ATTACHMENT 2

MILLSTONE NUCLEAR POWER STATION, UNIT NO. 1
ADEQUACY OF STATION ELECTRIC DISTRIBUTION SYSTEM VOLTAGES

MILLSTONE UNIT NO. 1

AUXILIARY BUS SYSTEM

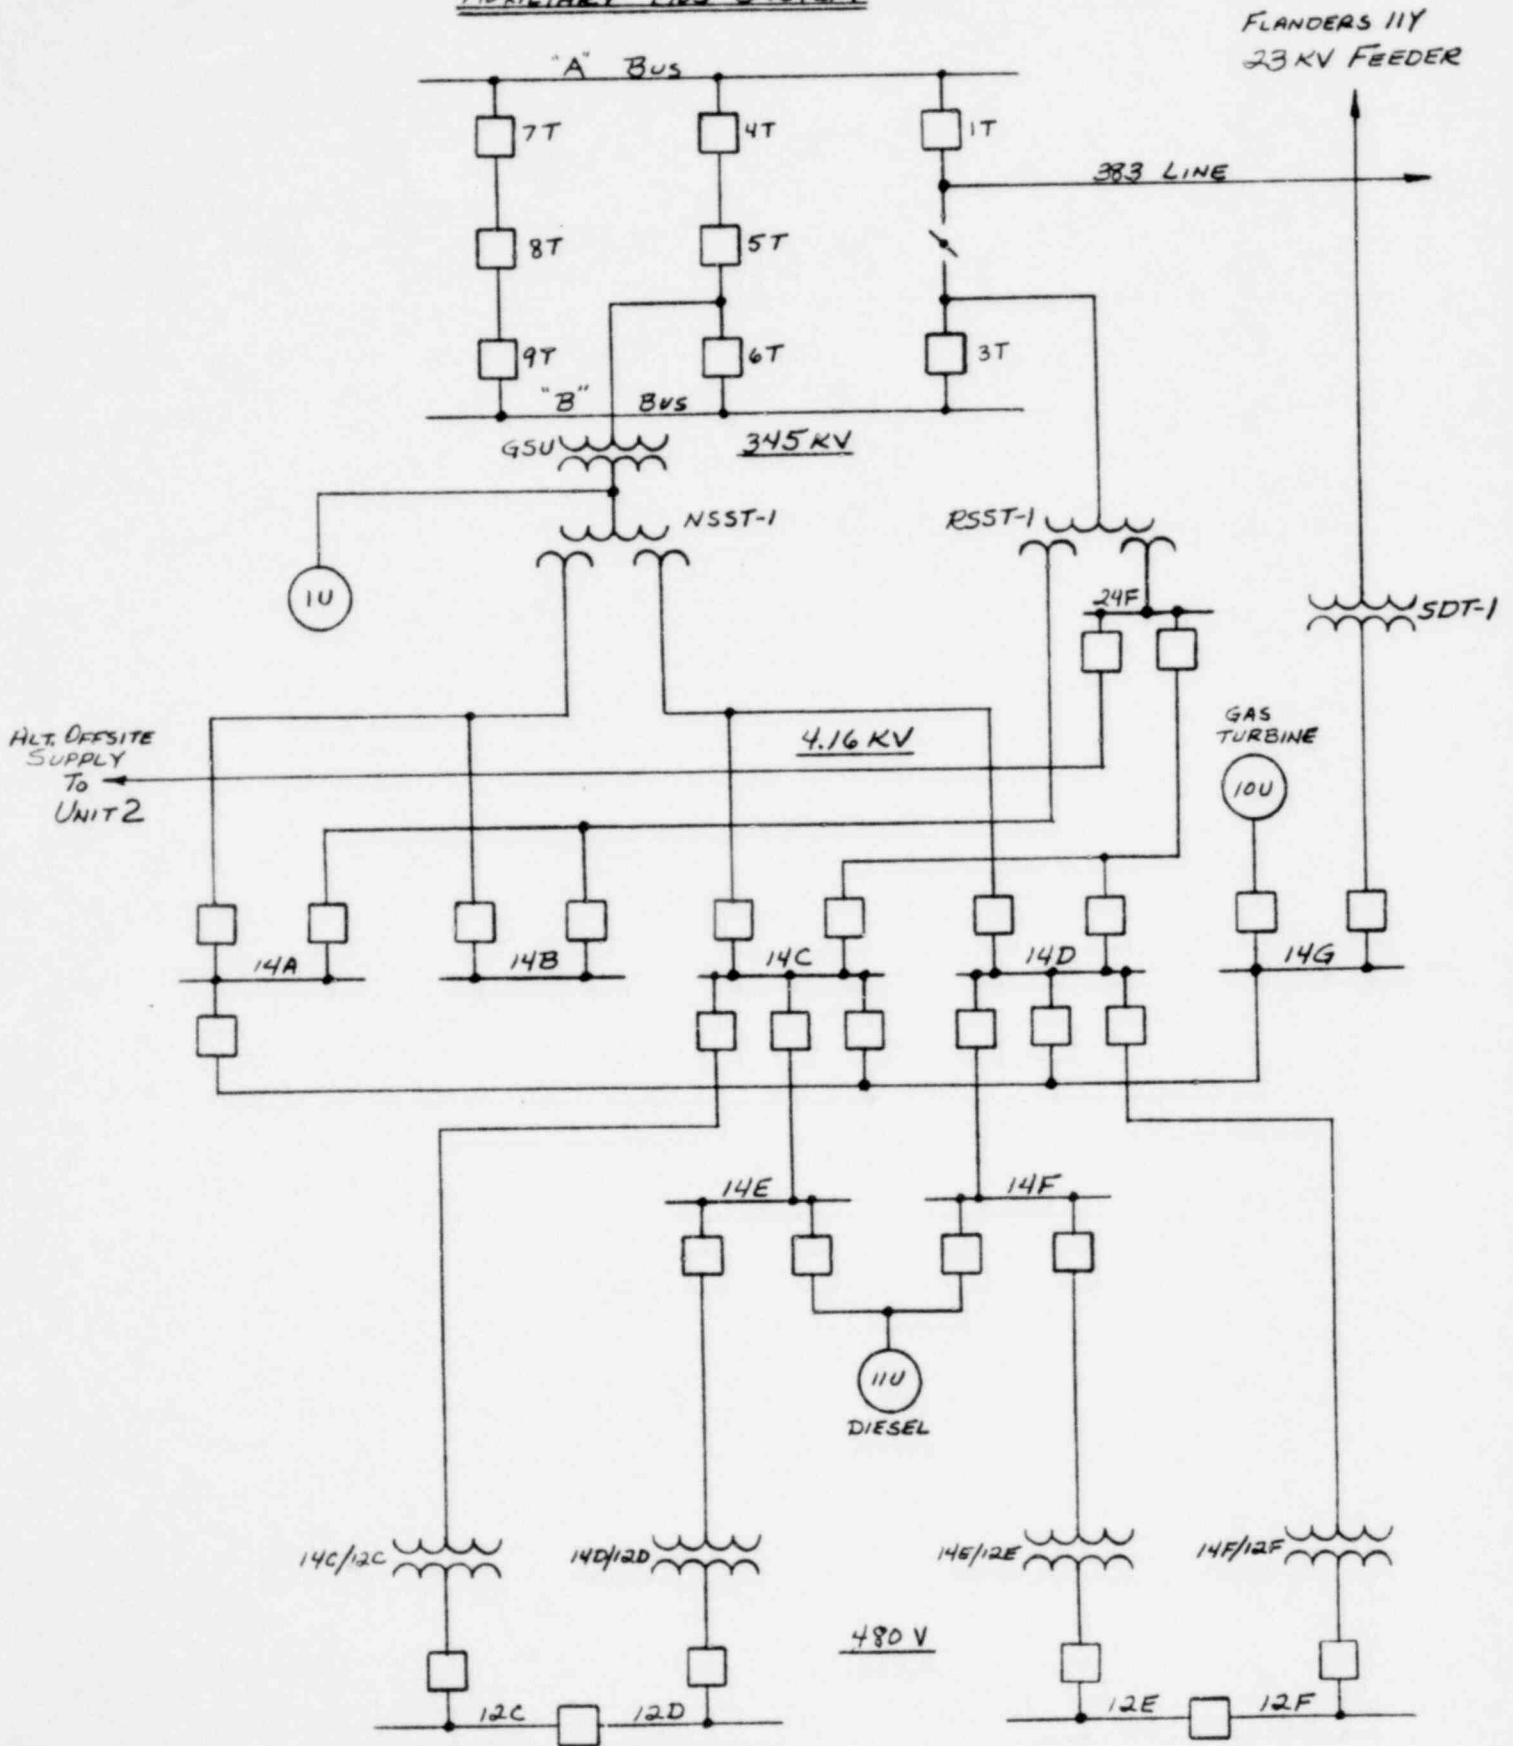
You are expected to review the electric power systems of your nuclear station to determine if there are any events or conditions which could result in the simultaneous or consequential loss of both required circuits to the offsite network to determine if any potential exists for violation of GDC-17 in this regard.

NNECO's review of the electric power systems, which are shown on the attached sketch, has revealed one event which could result in the simultaneous loss of both required circuits from the offsite network.

The event involves the failure of a particular span of 345 KV transmission line 383 which passes over the 23 KV feeder originating at Flanders 11Y Substation. If it is postulated that the span, in failing, falls on the 23 KV circuit, then by protective relay action 345 KV circuit breakers 1T and 3T will be tripped and the 23 KV circuit removed from service.

These actions, as can be seen from the attached sketch, remove both required circuits from the offsite network.

For this event, electrical isolation of the 383 line and restoration of the RSST-1 345 KV circuit can be accomplished by operator action in a time equal to or less than that required to secure the delayed access circuit. We have, therefore, concluded that, since this event presents a situation no worse than that associated with the permanent loss of the immediate access circuit (RSST-1), and since the probability of occurrence is extremely remote, no violation of GDC-17 exists for this event.
